MITSUBISHI MOTOR SALES OF AMERICA, Inc.

TECHNICAL SERVICE BULLETIN

MONTERO V6 OIL CAPACITY

NO. TSB-89-12-001
DATE June, 1989
MODEL Montero V6

Page 0-21

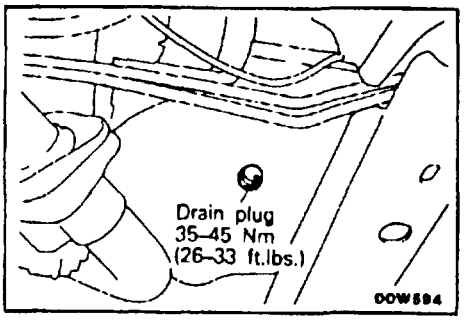
(1) After warming up the engine, remove the oil filler cap.
(2) Remove the drain plug to allow the engine oil to drain.
(3) Replace the drain plug gasket with a new one and tighten the drain plug.
(4) Supply new engine oil through the oil filler.

Engine oil total capacity:
<2.6L Engine> add 1/2qt. filter **4.9 liters (5.0 qts.)**
<3.0L Engine> includes filter **4.7 liters (5.0 qts.)**
~~**(including oil filter 0.4 liter (1/2 qt.))**~~
